**PROPERTY OWNERS WITHIN 500' CREVIER SUBDIVISION MODIFICATION**

**From:** Delia Fey <delia.fey@necog.org>  
**Sent:** Thursday, December 8, 2022 3:53 PM  
**To:** Jeff A. Gordon, M.D.; Dan Malo; Tracy Giarrusso  
**Subject:** Fw: Crevier Subdivision Modification - Perrin Road

**From:** John Navarro <johnnavarro@woodstockct.gov>  
**Sent:** Thursday, December 8, 2022 3:44 PM  
**To:** Delia Fey <delia.fey@necog.org>  
**Subject:** RE: Crevier Subdivision Modification - Perrin Road

SEPTIC SYSTEM DESIGN PLAN  
PREPARED FOR  
**RONALD PRACHNIAK**  
PERRIN ROAD  
WOODSTOCK, CONNECTICUT

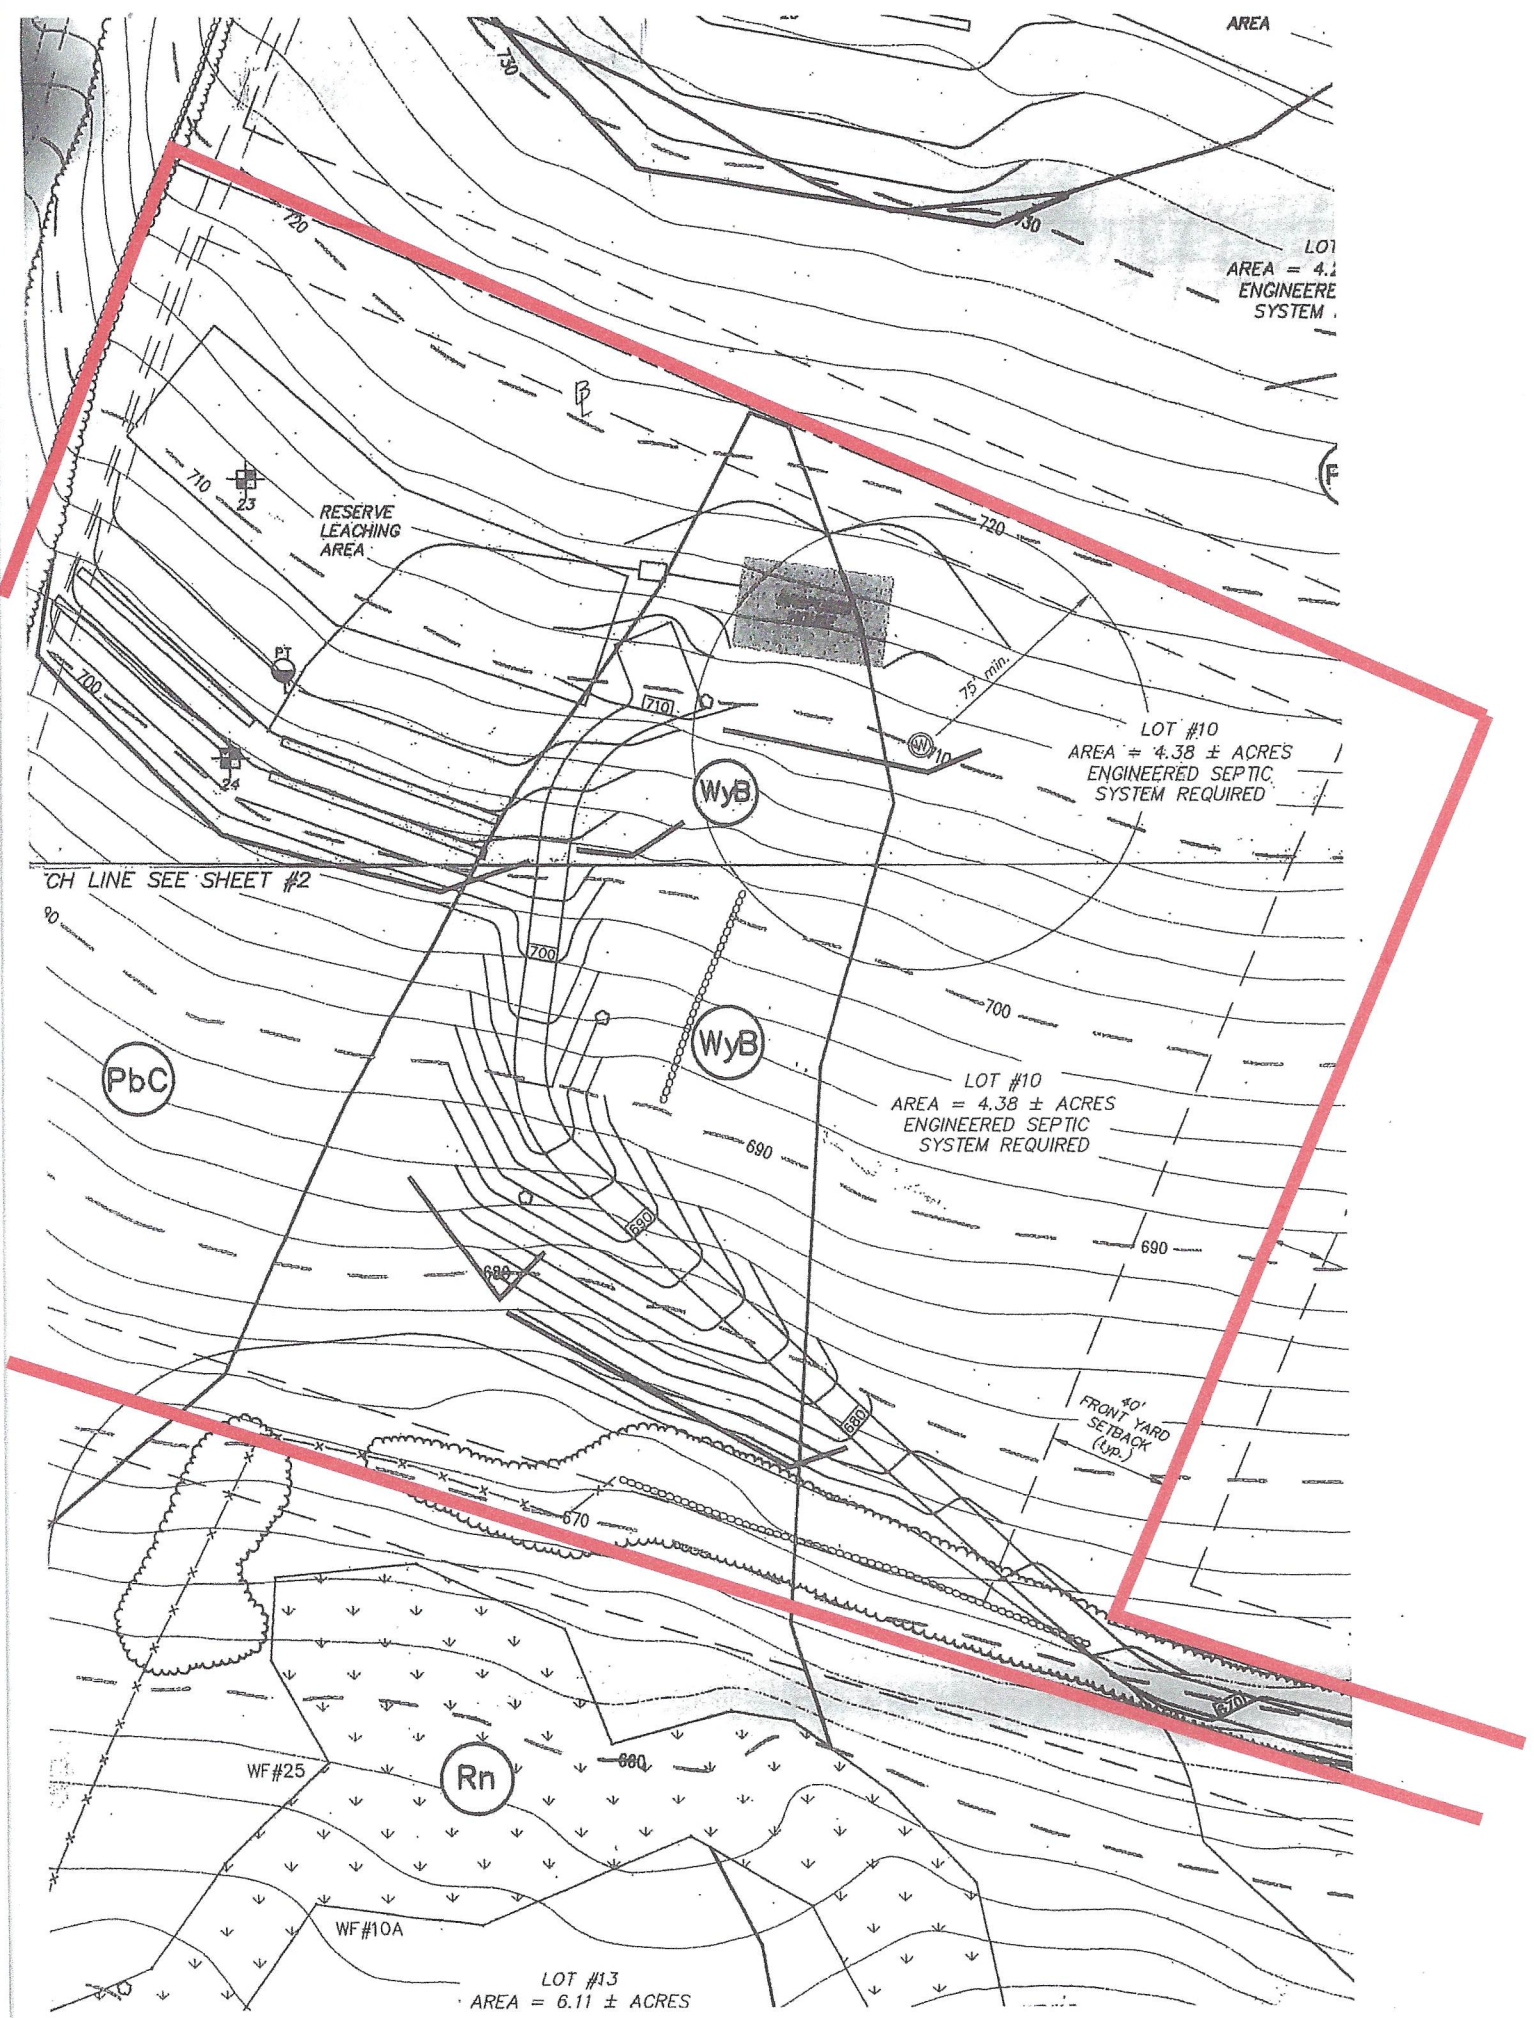
Hi Delia, I have been out to this location and other than a new driveway apron and a riprap lined ditch leading to the catch basin to the north of the driveway, I have no other concerns with the proposed shared driveway. Mr. Crevier can reach out to me and I can provide apron specifications and a description of the ditch leading to the basin. Thanks,  
John Navarro/ Woodstock DPW
